# CITY PLANNING COMMISSION

APPLICANT	Howard R. Perkins, Architect, 2304 N St., Sac, CA 95817				
OWNER	St. Paul Missionary Baptist Church, 4020 12th Ave., Sac, CA 95817				
PLANS BY	Howard R. Perkins, Architect, 2304 N St., Sac, CA 95817				
FILING DATE	10/21/88	ENVIR. DET.	Negative Declaration	REPORT BY	PW:kjr
ASSESSOR'S PCL. NO.	020-0074-001, 002, 003

- APPLICATION:**
- A. Negative Declaration
  - B. Special Permit to develop a two-story, 75,000 square foot church with a 2,175 seat capacity on 6.0+ acres in the R-1 zone
  - C. Variance to exceed the maximum 35 foot height limit by 20 feet to develop a 55 foot high detached bell tower
  - D. Variance to exceed the maximum 35 foot height limit by 4 feet to develop the 39 foot high main church building
  - E. Variance to construct a 9 foot high masonry wall (withdrawn)
  - F. Lot Line Adjustment to merge three vacant lots totaling 6.0+ acres

**LOCATION:** 3996 14th Avenue

# REVISED SITE PLAN

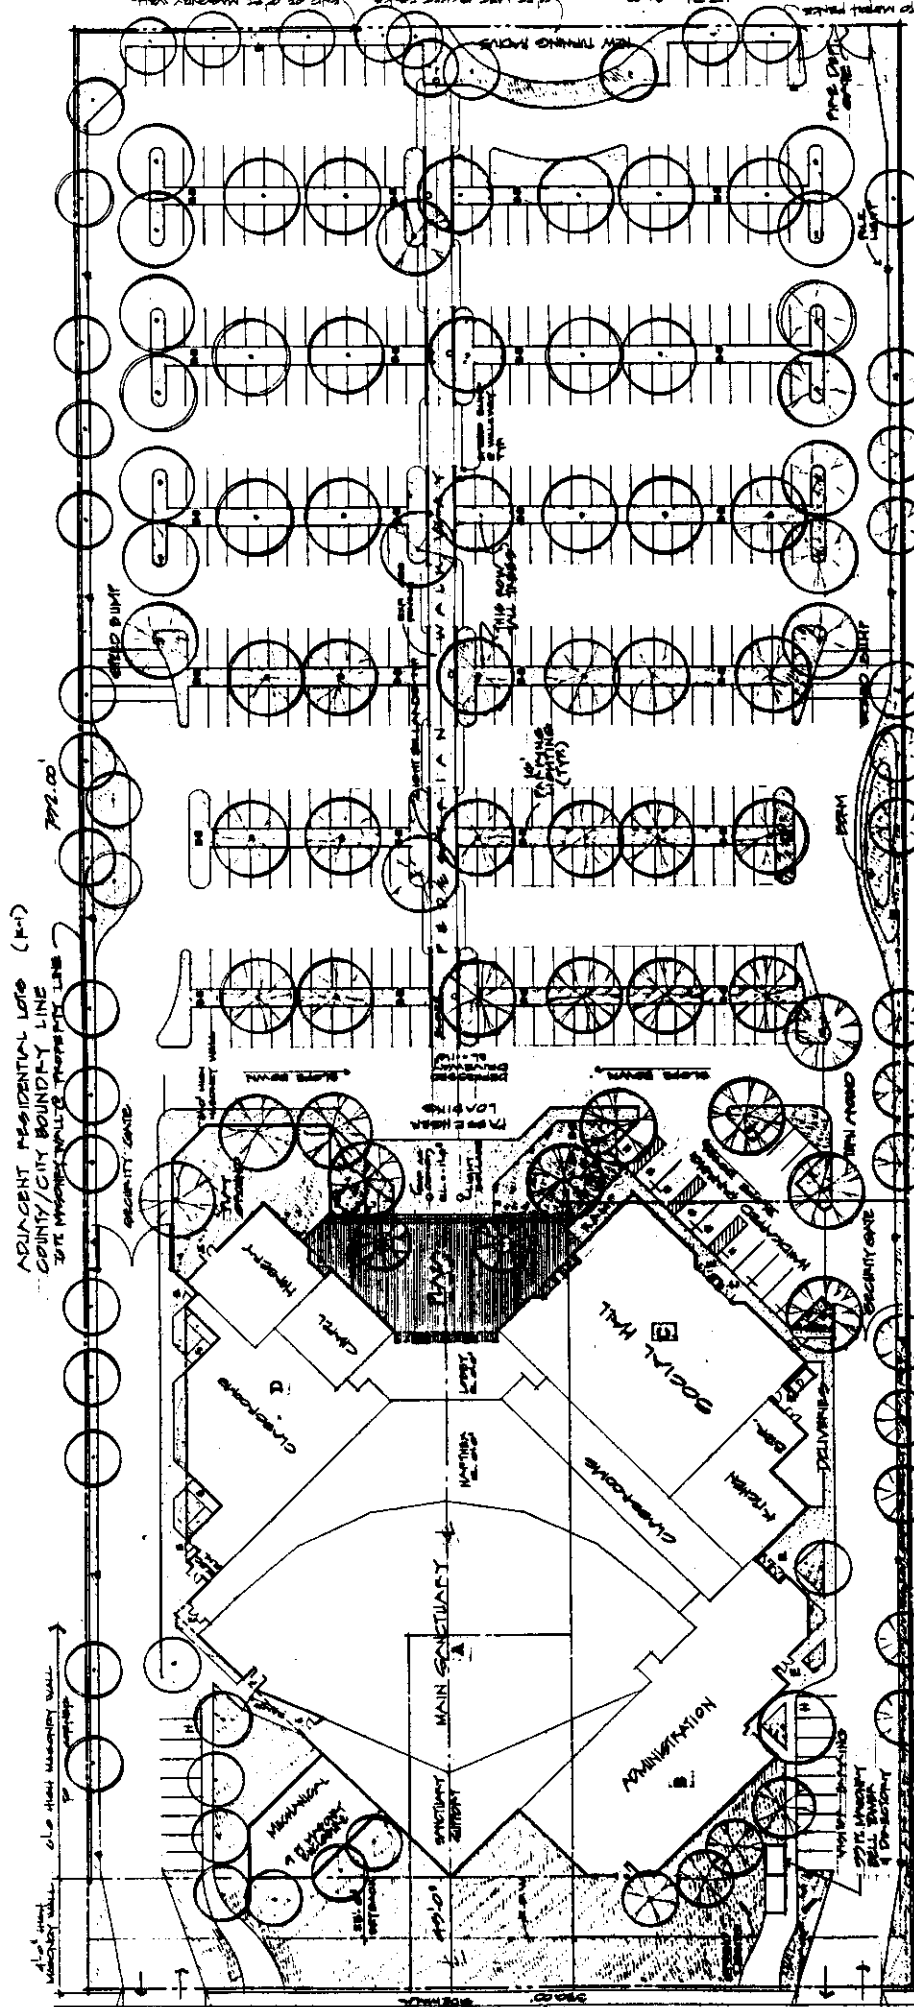
The submitted site plan indicates the placement of the church toward the northern portion of the site along 14th Avenue. The site has been designed so that the building will present a brick and stained glass face on 14th Avenue. The front yard building setback along 14th Avenue is 45 feet and the side yard setbacks are 40 feet. Parking for 390 cars including handicapped stalls will be located behind the church, out of vision from 14th Avenue. Parking lot access will be from driveways off of 14th Avenue along either side of the church as well as emergency vehicle access from 17th Avenue at the rear of the property. A pedestrian walkway made of exposed

Staff suggested revising the long expanse of driveways to create a more aesthetically pleasing sight line from 14th Avenue. The applicant agreed to incorporate a type of meandering driveway design by adding an extended planter area on each side of the respective driveways. The revision to the driveways helps break up the long monotonous line of the driveway of the original design. The applicant also agreed to additional planters along the pedestrian walkway that runs the entire length of the parking lot. The planters help both with the shading and the overall design of the parking lot and walkway. Staff had some concern regarding the treatment of the rear of the parking lot adjacent to 17th Avenue. More landscaping was needed in this area to lessen the impacts of the parking lot visually to the residential street to the south. The applicant has submitted a revised site plan that accommodates staff's recommendations of improving the site plan aesthetically and functionally.

A 6 foot masonry wall is proposed for the east and west perimeter of the site as well as a portion of the south perimeter. This wall should have a decorative design and must be reduced to 3 feet at the front 25 foot setback line. Along 17th Avenue at the rear of the site, a wrought iron fence is proposed from the end of the cul-de-sac to the southern property line including across the emergency access gate. The access gate should match the fence in design and materials. Each driveway has a security gate limiting access to the parking lot. These security gates should be made of wrought iron. All fencing, including walls and gates, should be reviewed and approved by Planning Staff prior to issuance of building permits.

The Zoning Ordinance currently requires one parking space per six seats for a church use. Based on the eventual total congregational capacity of the proposed church of 2,175; 362 parking stalls are required. The revised site plan indicates 390 parking stalls to be provided. Staff notes that no compact stalls are indicated. The City Zoning Ordinance allows up to 30 percent of the required parking to be compacts. Staff suggests the use of compact stalls in order to increase the total overall number of stalls provided.

1. Driveways to church must be a minimum of 10 feet from property line and perpendicular to 14th Avenue.
2. Handicapped stalls must be constructed to City Standards.
3. Construct improvements along 17th Avenue to match existing, including bulb at corner.
4. Remove and replace any substandard improvements.
5. All signage must conform to the City's Visibility Ordinance.

6. The security gates and emergency access gate shall be wrought iron and be reviewed by Planning Staff prior to issuance of building permits.
7. The applicant shall adhere to the attached revised site plan.

# ELEVATIONS

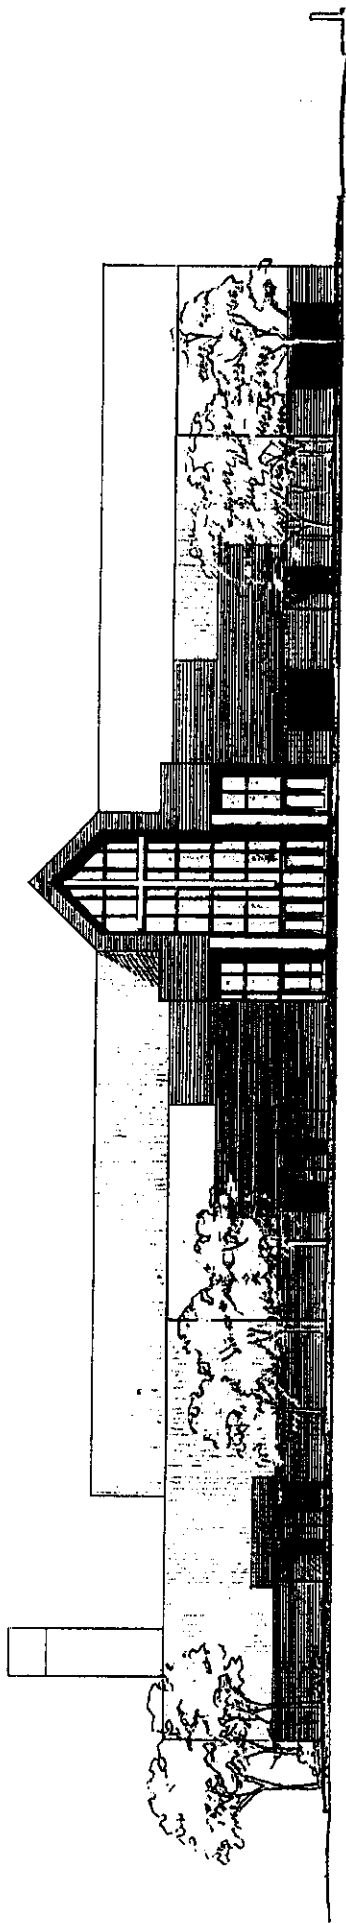
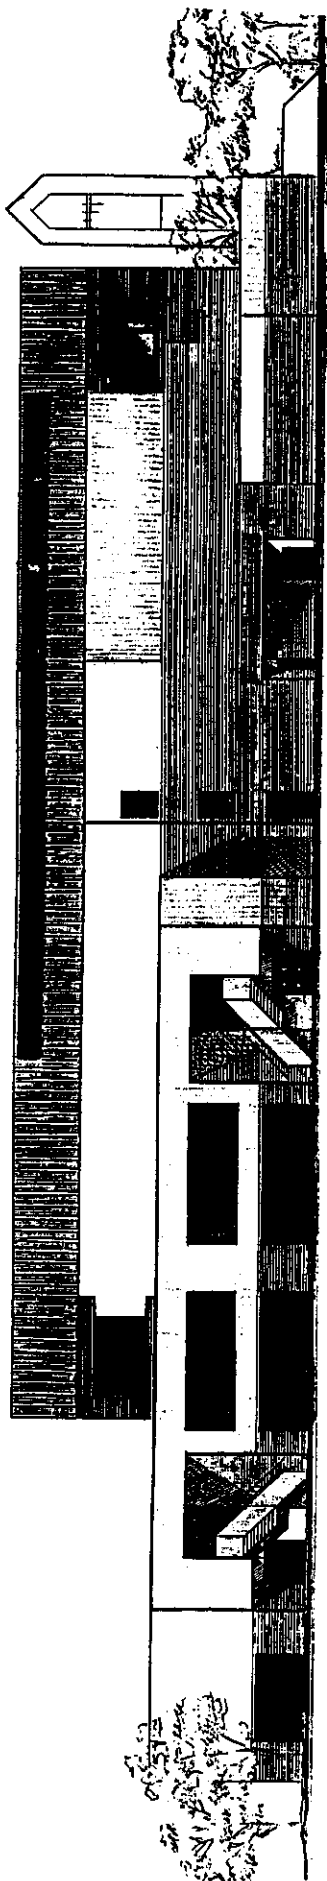
The proposed building is a 75,000 square foot, two-story structure consisting primarily of stucco and brick. A large stain glass window will be featured on the north elevation facing 14th Avenue. A skylight system with laminated glass will run along the top of the sanctuary. A 55 foot detached bell tower is proposed adjacent to the front of the church near 14th Avenue.

The Zoning Ordinance allows a maximum height of 35 feet in the R-1 zone. The applicant is requesting variances to allow the sanctuary and the detached bell tower to exceed the 35 foot height limit. The applicant is seeking a 4'0" height variance for the sanctuary in order to include height and sight lines for the balcony seating in the facility. In order to maintain proper site lines from the balcony to the platform area, and taking into consideration minimum vertical clearances of ceilings and structural elements, the applicant indicates it will be necessary to establish a roof parapet height of 39'0" above grade at the sanctuary. Staff can support this variance request because the impact of the additional height will be minimized. Only the sanctuary portion of the church will need to exceed the allowable height. The sanctuary will be centered in the site, with the high walls located as far as possible from property lines -- 85 feet from the east property line and 35 feet from the west property line to the nearest corner of the building. Additionally, the sanctuary will be located approximately 90 feet from 14th Avenue. The social hall and classroom wings will be a lower two-stories, and will have parapet heights of 26 feet. The portion of the building closest to 14th Avenue will be the one-story administration wing and will have a parapet height of approximately 14 feet.

The proposed bell tower is 55 feet in height consisting of a material and color compatible with the main structure. The applicant has indicated that the bell tower will only be constructed after the total completion of the church facility. No building plans for the bell tower have yet been developed. Staff recommends the applicant submit plans for the bell tower to planning staff for review and approval prior to issuance of building permits. The Commission has approved similar bell towers under similar circumstances throughout the City. Staff concurs with the applicant that bell towers are found with church developments and that its design will enhance building identification for church members. Therefore, staff supports the variance to exceed the 35 foot height limit for the proposed bell tower. The applicant indicates no specific plans for installation of an actual bell or other type of sound device at this time. The applicant should submit a sound device proposal to planning staff for review and approval prior to issuance of building permits for the bell tower.

8. The applicant shall submit a sign program for review and approval by the Planning Staff prior to issuance of sign permits.
9. The applicant shall submit separate detailed plans for the bell tower for Planning Staff review prior to issuance of building permits.
